PPR SUMMARY

**Colorado and Madison
556 E. Colorado Boulevard, Pasadena, CA**

**Plans and Elevations for 556 East Colorado Boulevard
Medical Office-Retail Project**

PPR Comments from City staff

Site Plan

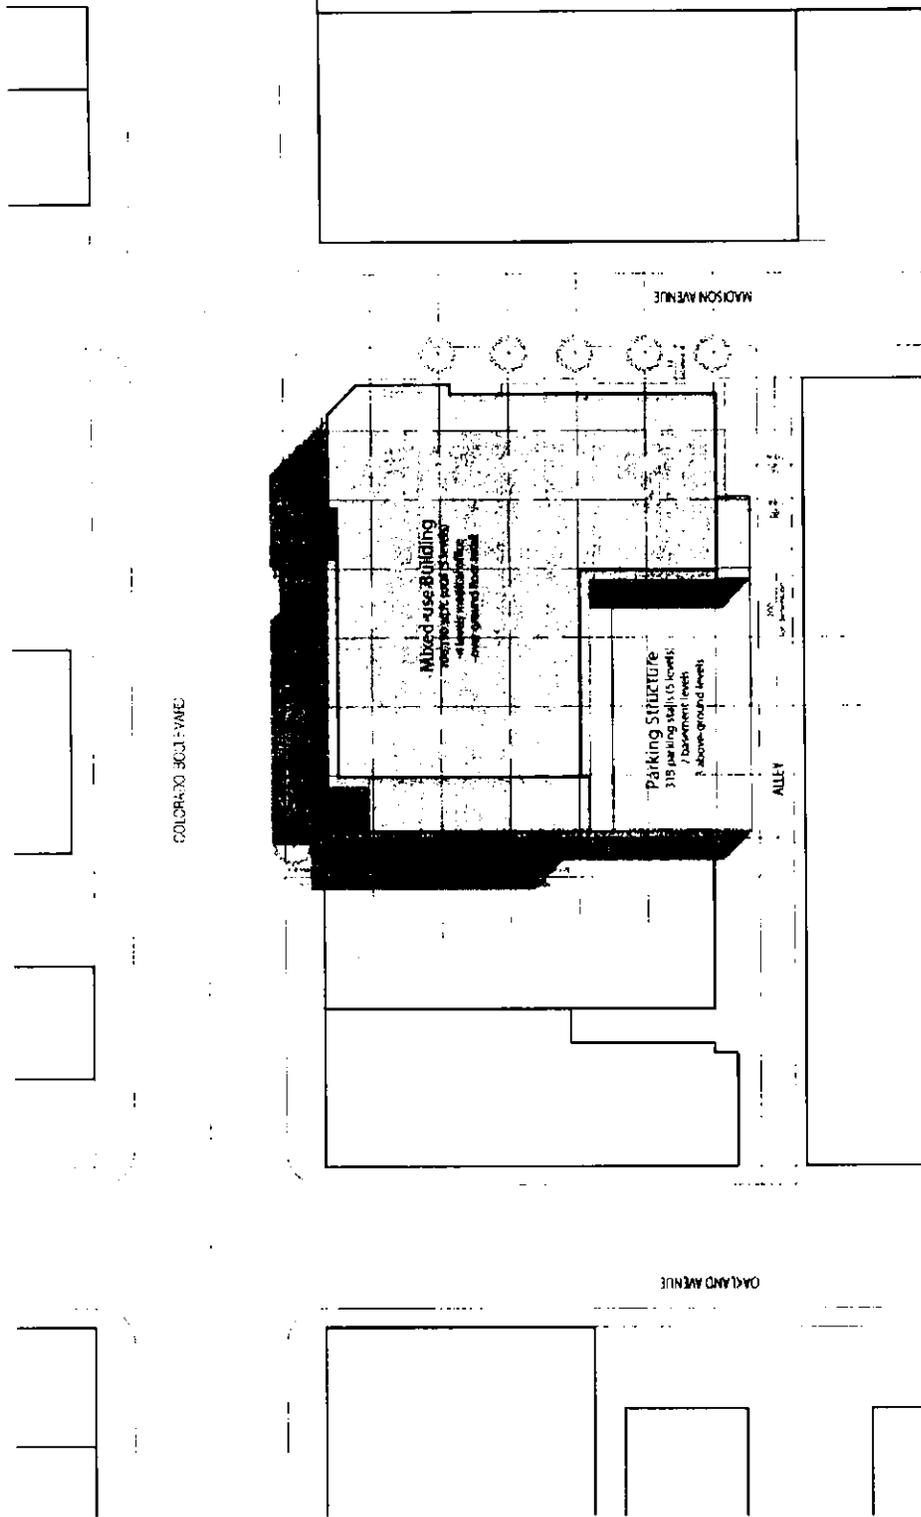
The site plan shows a total of 317 parking spaces including several tandem spaces on the lower levels. A Minor Conditional Use Permit is required for any tandem spaces.

Three loading spaces are shown on the site plan. The location and access to these spaces will be reviewed by the Transportation Department.

The small plaza at the northwest corner of the building may provide a space for pedestrian use along Colorado Blvd. However, the proposed plan has only a utilitarian stairway exit door opening onto this plaza, which seems to diminish its effectiveness

and does not comply with *CDDG guideline 2.2* (“Orient building entrances toward public space, and encourage adjacent ground floor uses that animate and enliven the space.”). The *Central District Design Guidelines* encourages mid-block and off-street paseos and walks (section 10), and one is specifically shown on the west side of this site in the *Playhouse District Streetscapes, Walkways, and Alleys Plan*. The proposed plaza could be extended to create a pleasant walkway on the west end of the site. Otherwise, the design may be judged deficient in terms of providing “linked plazas, courtyards, street, alleys and passages” (*CDP, page 8*). See also *Central District SP guideline 8.3.3* (“Extend the circulation patterns of public sidewalks through publicly accessible plazas, courtyard, alley walkways, paseos, and mid-block passages”).

Tandem Parking: The site plan includes tandem parking spaces. Tandem parking requires approval of a Minor Conditional Use Permit and shall contain a condition that a full-time parking attendant be on duty at all times the parking facility is available for use.

0 15 30 60
Ground Floor Plan

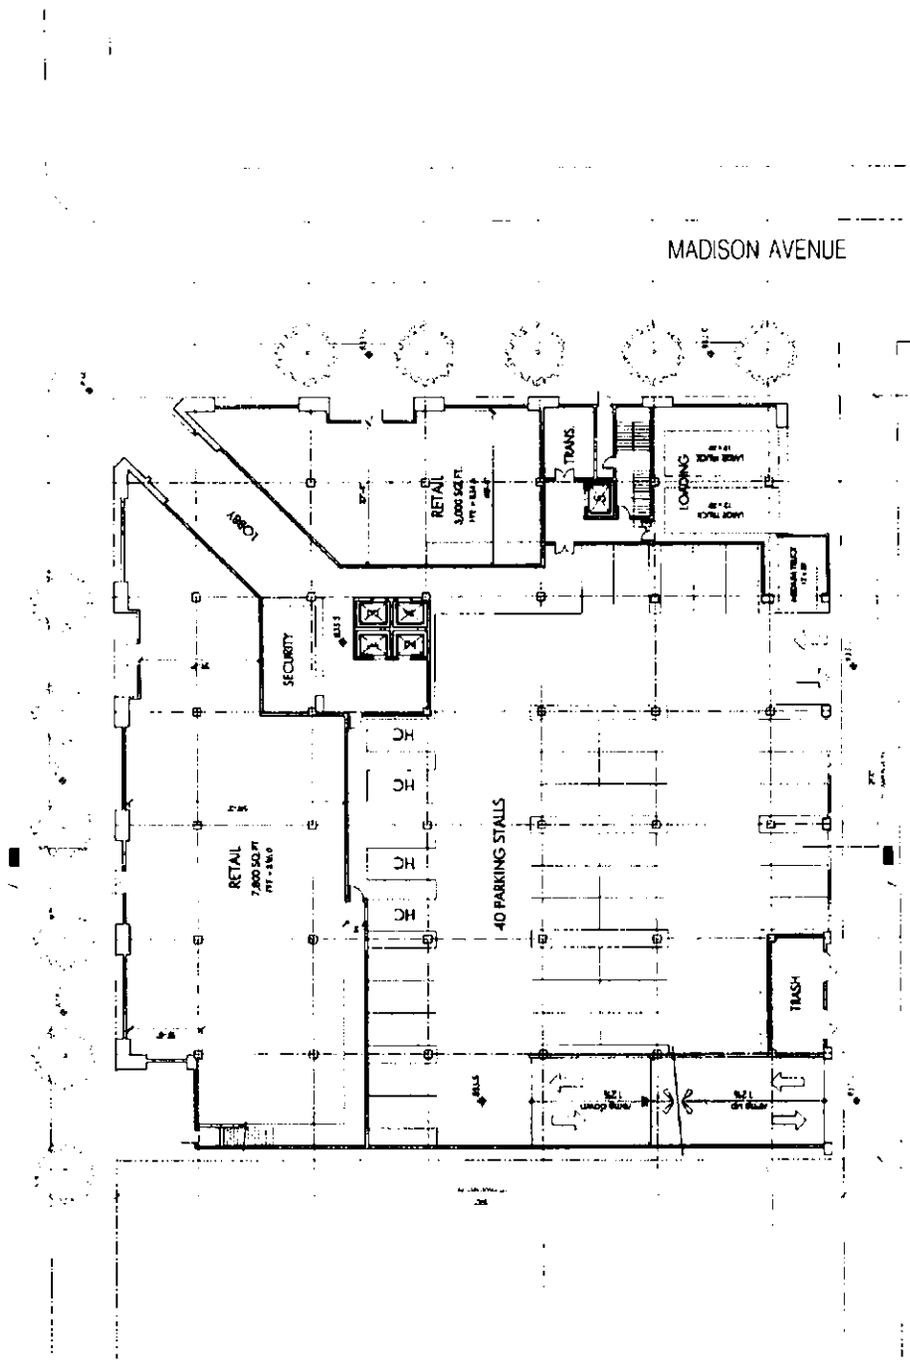
The loading area is located on Converse alley at Madison Avenue, with a solid wall on the Madison Avenue side. To further mitigate the view, staff recommends the applicant consider roll-up doors to enclose the loading dock when there are no trucks on site

Although the loading zone does not fully comply with *Central District Specific Plan* guideline 9.7.2 ("Locate service, loading, and storage areas away from public streets and public spaces, as far as feasible."), the loading zone's solid wall appears to minimize views of this function from the street. In order to further mitigate the view, staff recommends that the project designers consider adding roll-up doors to enclose the loading docks when there are no trucks at the site.

Madison Ave. - East Elevation

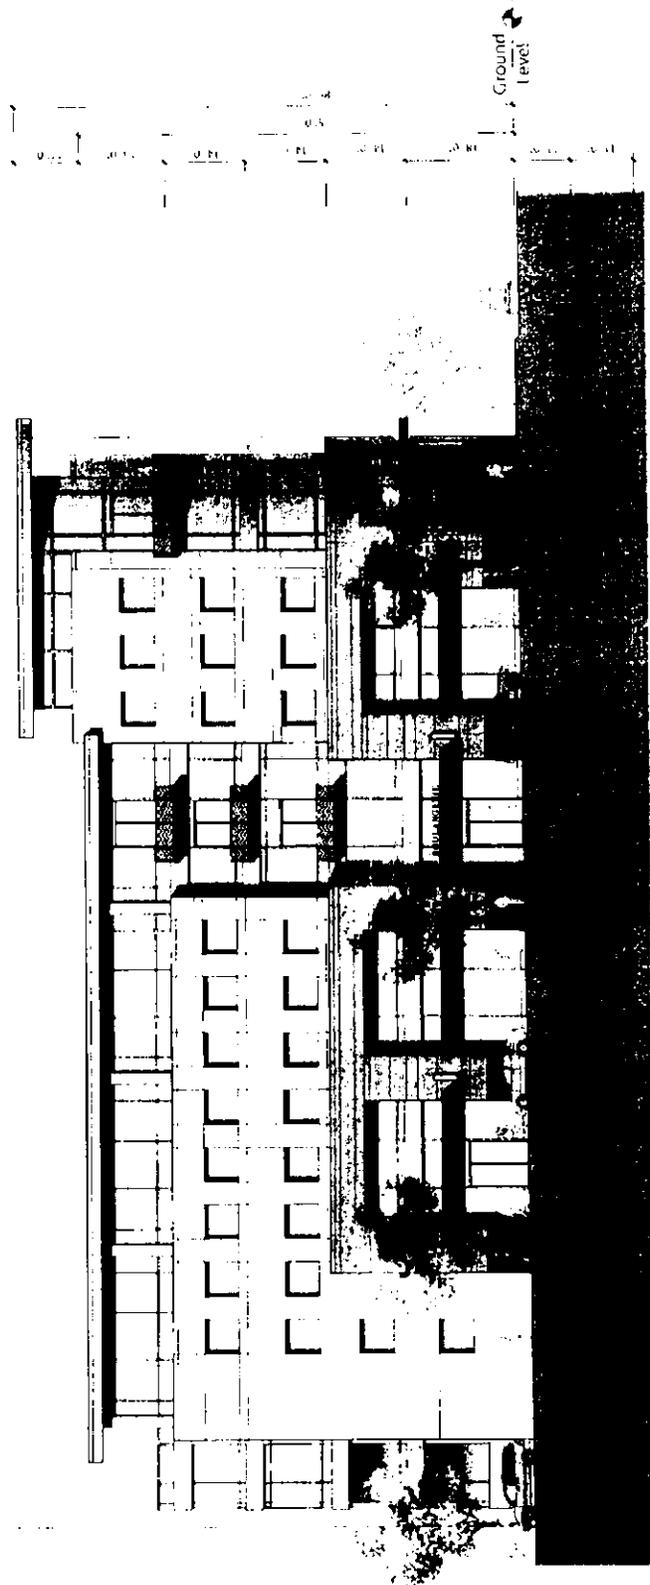
Height: Current: 130 feet. Proposed: 75 feet with a maximum of 90 feet using height averaging. Height averaging allows additional height over no more than 30% of the building footprint on a development parcel (excluding parking garages) provided that the average height of that footprint does not exceed the otherwise required maximum building height. Height averaging requires approval from the Design Commission. The proposed elevations show a maximum height of 86 feet, which would require Design

Commission approval and the submittal of a roof plan that indicates how the height averaging requirements are being met.
